VIRGINIA ELECTRIC AND POWER COMPANY  
RICHMOND, VIRGINIA 23261

Serial No. 143  
NO/WDC:acm  
Docket No. 50-280  
License No. DPR-32

RELIEF REQUEST FROM ASME XI HYDROSTATIC TEST  
SURRY POWER STATION UNIT 1

11448-FM-64B.A

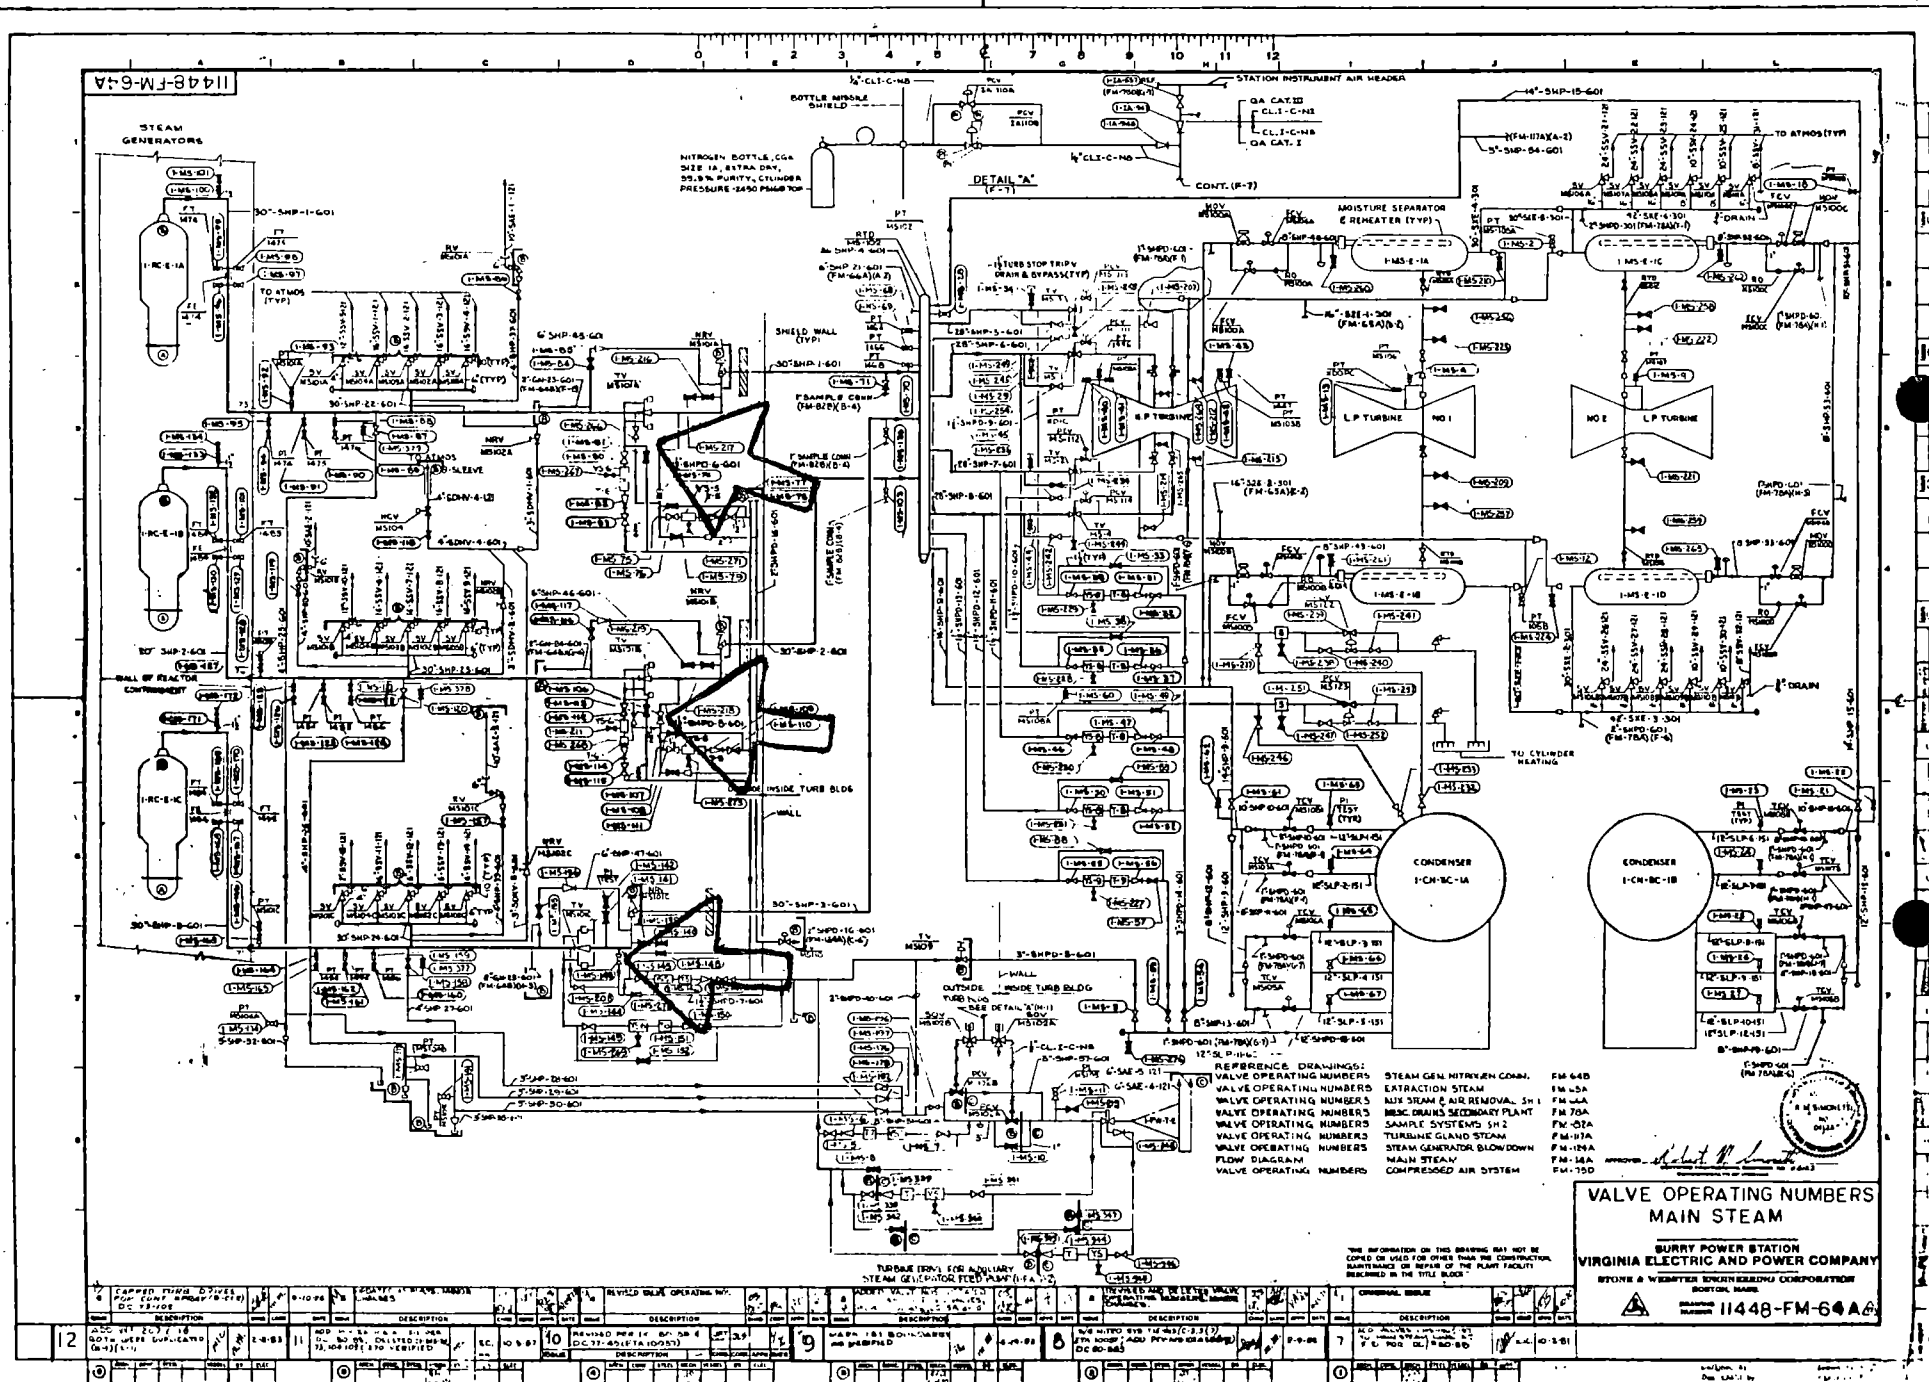
Specifically it is planned to replace three 1 1/2 inch socket welded drain valves (1-MS-266, 1-MS-106, and 1-MS-143) and one 2 inch socket welded manual isolation valve (1-GN-3), which are just downstream of the main steam trip valves (drawings attached). The governing code ASME XI 80W80 requires a hydrostatic test (IWA 4400 and IWC-5222) for such a repair/replacement. As evidenced by the attached drawings this replacement would require a hydrostatic test of all three steam generators and a considerable portion of attached main steam piping. This test is considered especially difficult and impractical in nature.

Alternate testing proposed is a surface examination (liquid penetrant) and a visual examination (VT-2) in conjunction with a system inservice pressure test (IWC-5221) during start-up, following the refueling outage.
